10/712,261

James D. Velke

Office Action Summary

DETAILED ACTION

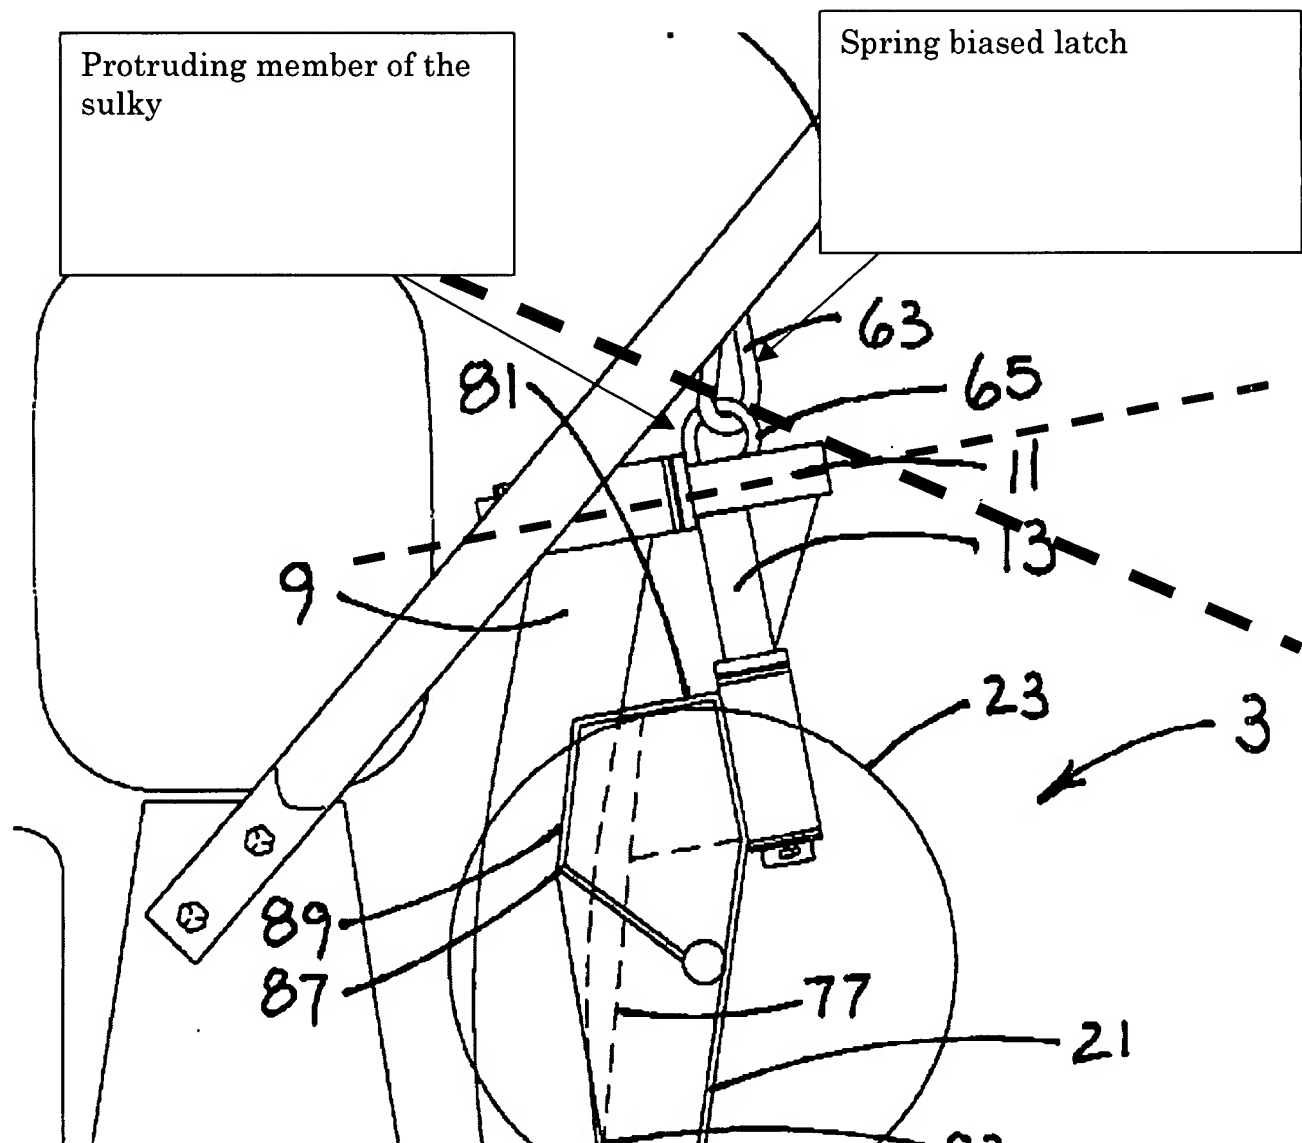
Velke discloses the claimed device: an engine (53, col. 6, ln 8-11); a sulky (3) comprises a substantially vertical pivot axis structure (fig 12, vertical pivot 11), a foot platform (21) pivots relative to a front arm (9) about the same pivot axis above; a latch assembly for coupling a protruding member (65) member of the sulky to a spring-biased latch (81) as defined in the claim & angles shown with dashed lines as shown in the figure below:

the latch assembly is located under the dashboard of the mower (fig 12); a buttress plate (29), so that a leading portion (79) of the sulky capable of hitting the buttress plate; the sulky extends outwardly from the vertical pivot axis of the sulky (fig 12); except for specifying the link (ref 63) clearly as "carabiner" or "locking snap hook" or "spring biased latch."

It would have been obvious to one having ordinary skill in the art at the time the invention was made to know that the snap-lock retainer / spring biased latch (ref 81) of Velke is a “carabiner” or “locking snap hook” or “spring biased latch” as demonstrated by Klingier/Brainerd/Gray/Dunn that it is well known, and it is widely used across many arts, including the lawn mower art.
